## ADDENDUM 02

DATE 09.13.22  
PROJECT NO. 2141  
PROJECT LOGAN FAMILYSEARCH CENTER REMODEL  
FROM STUDIO 333 ARCHITECTS

*This Addendum consists of 1 page and the attached Drawing Sheets E0.3, E4.31, E5.31, E5.32, E5.33, E6.31 and E1.31.*

1 1ST LEVEL TELECOM PLAN  
SCALE: 3/16" = 1'-0"

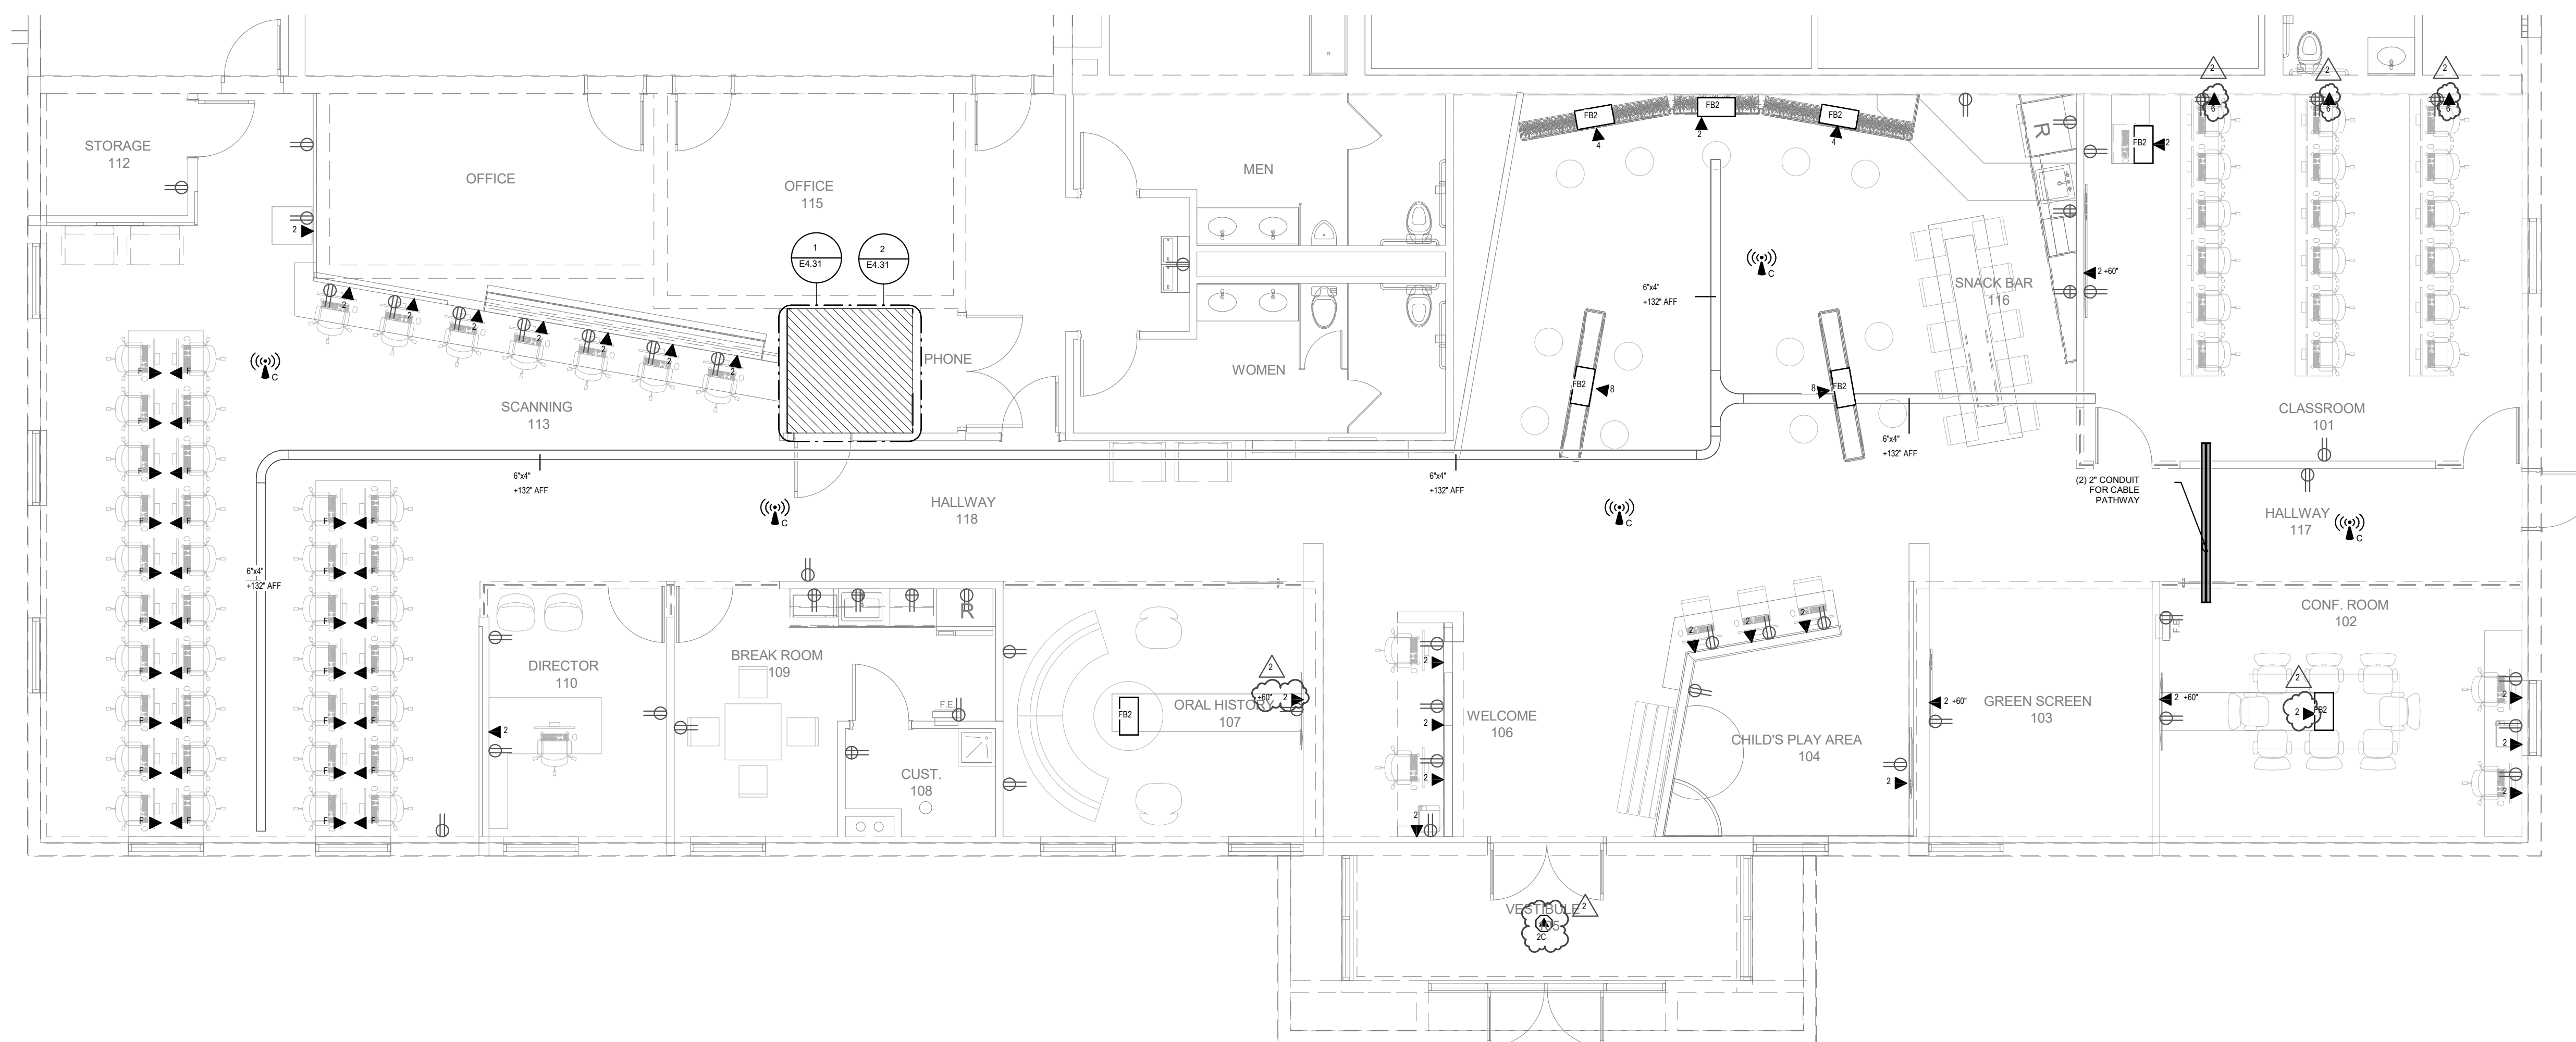
1. Sheets E0.3, E4.31, E5.31, E5.32, E5.33, and E6.31:
  - a. Add these sheets, describing the data design, to the drawing set.
2. Sheet E6.11:
  - a. The Blackjack track system is an approved alternate to the Axis Stencilflex system.
3. Sheet E1.31:
  - a. Add this sheet, which adds data jacks throughout the facility, to the drawing set. Ignore the clouded symbols--all work on this sheet is new.
